1989 - 1991 Corvette: Service Bulletin: No/Delayed Reverse When Cold

Subject: NO/DELAYED REVERSE WHEN COLD INSTALL REV.
INPUT CLUTCH SEAL

Bulletin Number: 91-493-7A - (03/11/1992)

SUBJECT: ----- No Reverse/Delayed Reverse Cold (Install Long Lipped Reverse Input Clutch Piston Outer Seal)

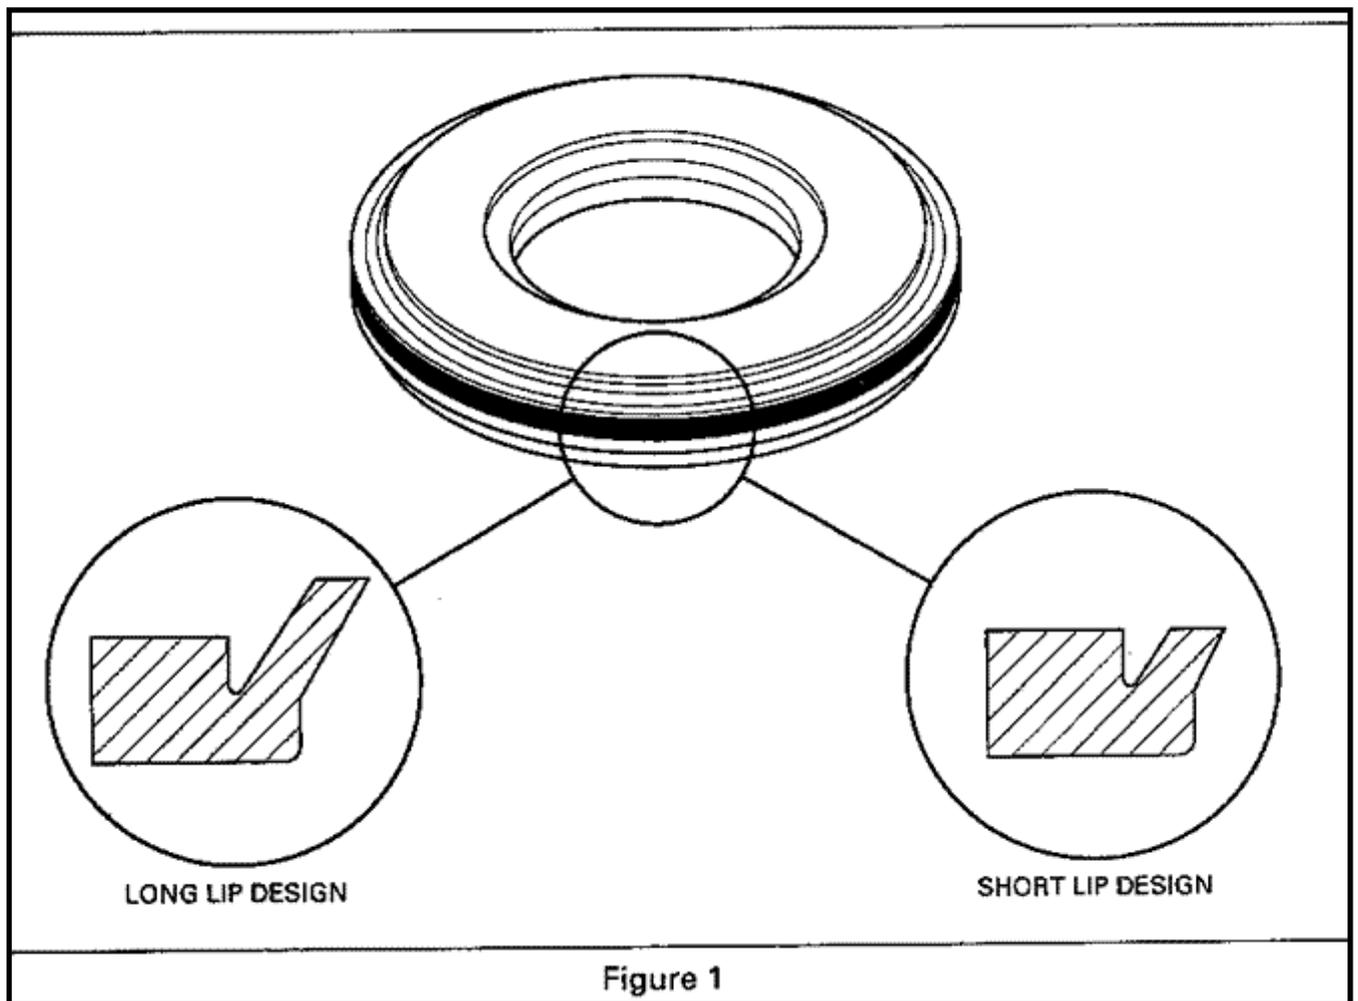
If a transmission has a 'no reverse' or 'delayed reverse' condition, inspect the reverse input clutch piston outer seal. Determine if the seal is a 'short lip' or 'long lip' design by comparing it to Figure 1. If it is a short lip design, replace it with a long lip seal contained in the service packages listed under Service Parts Information.

If the reverse input clutch piston outer seal is a long lip design, or the newly installed long lip seal doesn't alleviate the delayed reverse condition, the reverse input clutch housing may be out of round. Inspect the housing and replace if necessary.

The long lipped seals are available in several service packages. Description
Part Number

Pkg - Overhaul Seals and Gaskets 8683958

Pkg - Overhaul Repair Complete 8683959
